**REMARKS***Claim Rejections Under 35 U.S.C. § 112*

ANNOTATED MARKED-UP DRAWING  
Inventor: Andrei Mihnea  
A METHOD FOR PROGRAMMING AND ERASING AN NROM CELL  
Atty Docket No. 400.234US01 Serial No. 10/636,173

*Fig. 1A*

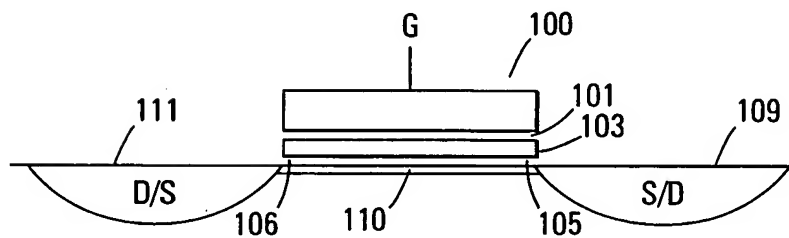
The drawings were objected to as failing to comply with 37 CFR 1.83(a). The Examiner stated that the two source/drain regions and an NROM cell embedded in a CMOS device must be shown or canceled from the claims. Applicant respectfully traverses this objection.

The two source/drain regions are clearly shown in both Figure 1A and 1B as reference numbers 109 and 111. In order to fit the labels “source/drain” into the small areas, these terms had to be abbreviated “D/S” and “S/D”. These areas are clearly described as source and drain at paragraph 22 of the specification. While the phrase “drain/source” is not explicitly used in the specification, it is well known by those skilled in the art that only one area (109 or 111) is a drain and the other area (111 or 109) a source at any one time. Paragraph 22 clearly states that the

source and drain functions change with the direction of operation of the cell. Therefore, while one area 111 is a drain (i.e., D), the other area 109 is a source (i.e., S), hence the D/S label. Similarly, when the first area 111 is a source, the other area 109 is a drain, hence the S/D label. Therefore, the two source/drain and drain/source regions that are recited in the claims are clearly discussed in the specification and shown in the drawings.

*Fig. 2*

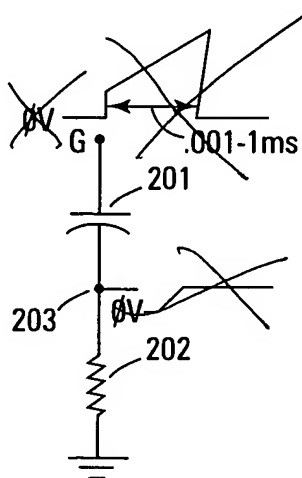
The drawings were objected to as failing to comply with 37 CFR 1.84(p)(5) because they included the following reference character(s) not mentioned in the description: 0V and .001-1ms in Fig. 2; CONTROL, DATA, and ADDRESS in Fig. 6. Applicant respectfully traverses this objection.

The labels “0V” and “.001-1ms” are discussed in the specification at paragraph 29 where it states that “[a] linear ramp voltage is applied to the control gate of the cell 307. In one embodiment, this voltage starts in the range of 0 to 6V and goes up to 4 to 12V for a time in the range of 0.001 – 1 millisecond.” Since the circuit of Fig. 2 is the equivalent circuit of the NROM cell of Fig. 1 and the gate connection “G” is clearly labeled in both figures, it is clear that the ramped voltage of Fig. 2 with the labels “0V” and “.001-1ms” is being applied to the gate connection as is referred to by paragraph 29. However, in the interest of expediency, Applicant has deleted these references from Fig. 2.
